Grid Code Modification Proposal Form Email to gridcode@eirgrid.com			
Title of Modification Proposal: MPID 345 Fault Ride Through, RoCoF and Post Fault Active Power Recovery for Demand Facilities			
MPID (EirGrid Use Only): MPID345			
Date:	17/11/2025		
Company Name:	EirGrid		
Applicant Name:	Simon Tweed		
Email Address:	Gridcode@EirGrid.com	Tel:	01 677 1700
Grid Code Version:	16		
Grid Code Section(s) Impacted by Modification Proposal:	CC.7.4.2; CC.7.4.3; CC.7.4.4.		
Modification Proposal Justification: EirGrid (Ireland's Transmission System Operator (TSO)) and SONI (Northern Ireland's TSO) are responsible for operating and developing the respective transmission systems of Ireland and Northern Ireland in a secure and coordinated manner. A growing challenge to meeting these responsibilities is the impact on the power system of the response of some large Demand Facilities (primarily data centres) to faults on the transmission system. Data centres are a significant and growing component of Ireland's electricity demand (there are no large-scale data centre facilities currently in operation in Northern Ireland). There is over 2000 MVA of data centre demand, and other new technology dem

Figure CC.7.4.3.2: Voltage-against-time profile at the connection point for fault condition

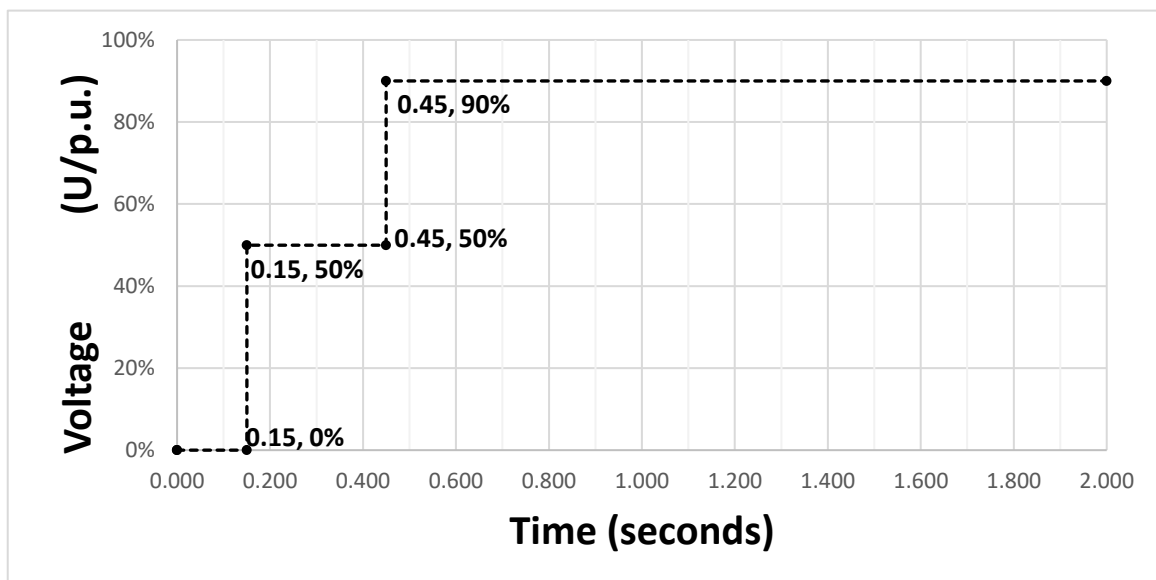
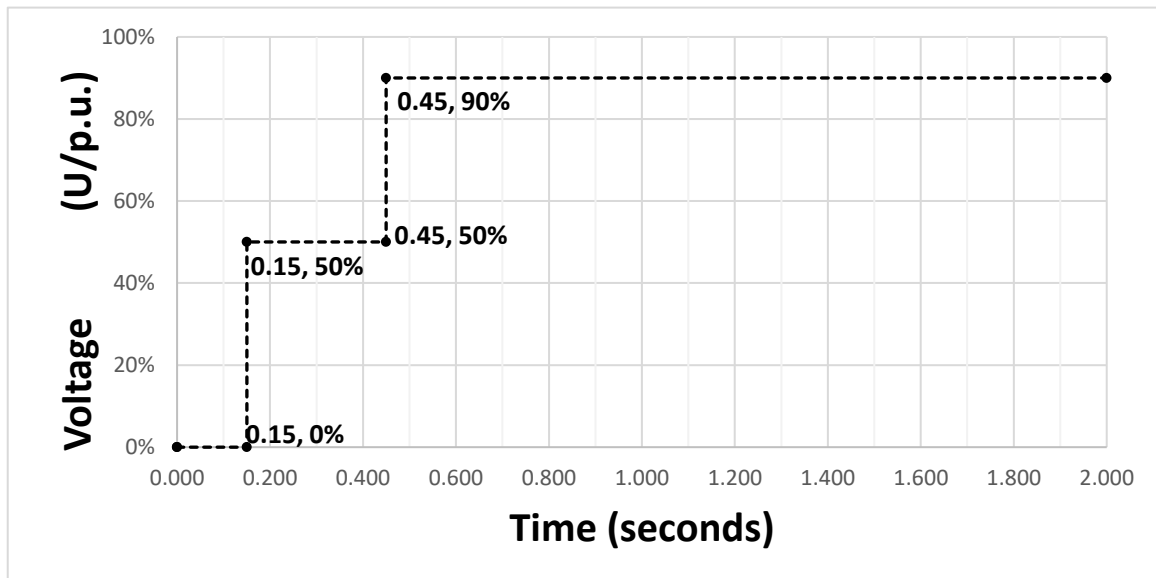
1- Fault Ride Through (FRT) Requirements: The TSOs require that demand facilities must remain connected and operate stably during and after any fault disturbance, provided the voltage deviation stays within the specified voltage-against-time profile at the connection point. This

Additionally, feedback requested clarification on what 'remain connected' means within the Fault Ride Through requirements. In response, the TSOs clarified that "remain connected" means that the customer's facility must remain electrically connected to the transmission system. During the voltage dip, demand facilities may switch their demand to backup systems, but they should restore at least 90% of their pre-fault demand within 500 milliseconds after fault clearance and voltage recovery to 90% of nominal voltage.

CC.7.4.3.2 **Demand Facilities** shall remain connected to the **Transmission System** during and following any **Fault Disturbance** on the **Power System** which results in a **Voltage** deviation which remains on or above the voltage-against-time profile specified in Figure CC.7.4.3.2 at the **Connection Point**. Following clearance of the **Fault Disturbance**, the **Demand Facility** should return to at least 90% of its prefault **Active Power Demand** within 500 ms of the **Transmission System Voltage** recovering to 90% of the nominal **Voltage**. The post **Fault Disturbance** ramp up rate for the **Demand Facility**, shall be coordinated and agreed between the **TSO** and the **Demand Facility** owner. The voltage-against-time profile specifies the required minimum capability as a function of voltage and **Fault Ride-Through Time** at the **Connection Point** before, during and after the **Fault Disturbance**.

CC.7.4.3.2 **Demand Facilities** shall remain connected to the **Transmission System** during and following any **Fault Disturbance** on the **Power System** which results in a **Voltage** deviation which remains on or above the voltage-against-time profile specified in Figure CC.7.4.3.2 at the **Connection Point**. Following clearance of the **Fault Disturbance**, the **Demand Facility** should return to at least 90% of its prefault **Active Power Demand** within 500 ms of the **Transmission System Voltage** recovering to 90% of the nominal **Voltage**. The post **Fault Disturbance** ramp up rate for the **Demand Facility**, shall be coordinated and agreed between the **TSO**

and the **Demand Facility** owner. The voltage-against-time profile specifies the required minimum capability as a function of voltage and **Fault Ride-Through Time** at the **Connection Point** before, during and after the **Fault Disturbance**.
